PART B – AEIS

13. AQUATIC FAUNA

Figure 13-1 Glebe Weir/Nathan Dam – days of down out / downstream fish passage per water year

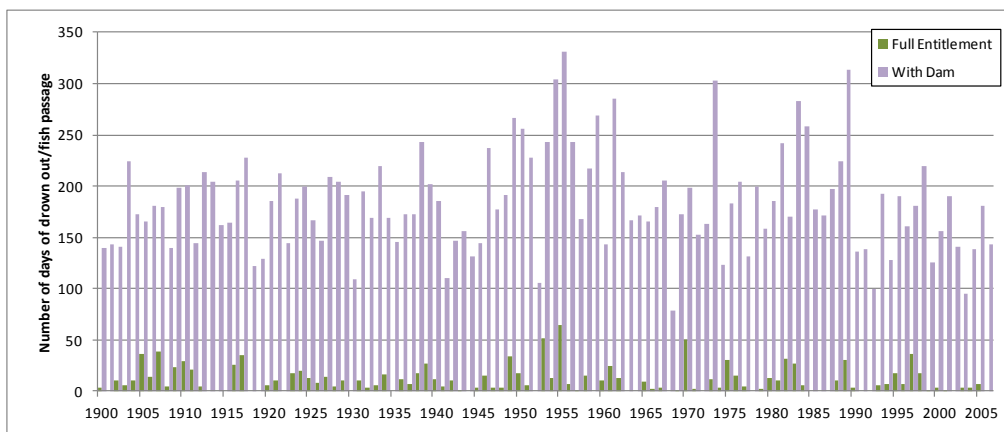
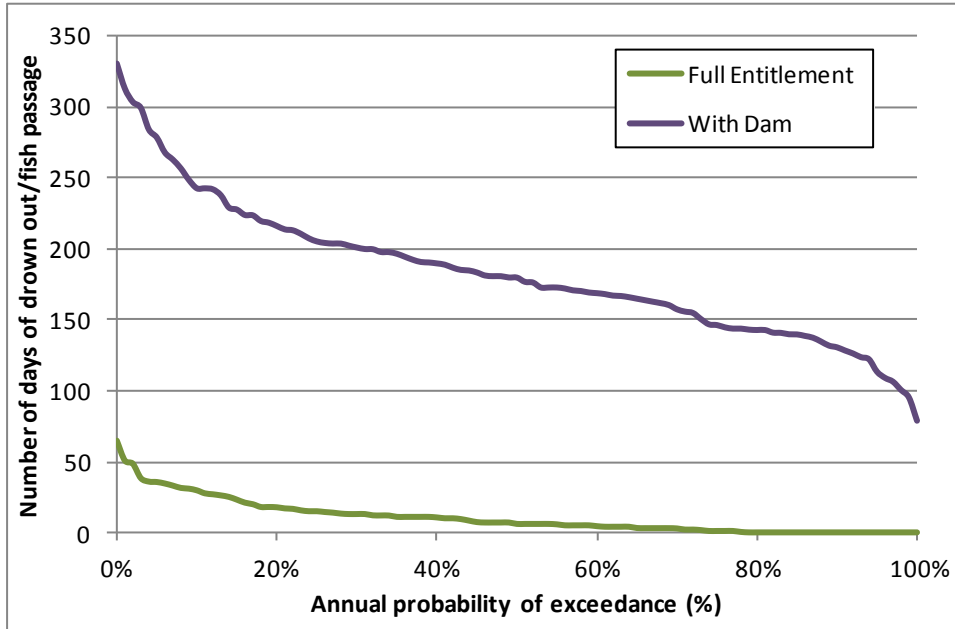
With respect to the existing downstream barriers, one submission requested discussion on the effect of reduced flooding downstream of Nathan Dam on drown out of existing weirs and thereby any reduction in opportunity for fish to pass these barriers. The weirs were shown in Figure 13.4. Updated hydrological modelling to assess passage was based on the current IQQM model for the catchment and incorporated the latest dam operations strategy. Downstream passage opportunity was defined as periods where a depth of water of at least 30 cm was passing over the weir. For upstream passage, the difference between headwater and tailwater levels needed to be less than 20%.

The potential for fish passage improves at Glebe Weir because it currently has no fish transfer device and will be replaced by Nathan Dam which will incorporate such a device. At the five downstream weirs within the water supply scheme, downstream passage is currently possible between 3% and 12% of the time (over a simulation period of 108 years or 39,446 days) while upstream passage is possible between 0.4% and 3.7% of the time. With the dam in place these will reduce to between 2% and 11%, and 0.3% to 2.7% respectively. The impact varies between years with higher flow years being less impacted but with extended periods of no opportunity during droughts. The comparable opportunity for passage in the natural case is unknown because the location of natural barriers was not mapped before the weirs were constructed however drought or very low flow periods would always have provided little or no opportunity for fish movement. Opportunity for upstream movement past weirs without fish transfer devices is limited to flood periods.

Figure 13-1 and **Figure 13-2** show the improvement at Glebe Weir while **Figure 13-3** and **Figure 13-4** show the reduced opportunity for downstream fish passage at Gyrenda Weir which is the most impacted because it is closest to the dam. Moura Weir and Neville Hewitt Weir currently have fish transfer devices fitted so drown-out is not the only period of available fish passage. Operation of the water storage has been modelled with no change to the operating rules of these downstream storages hence the operation of the existing fish transfer devices will not alter.
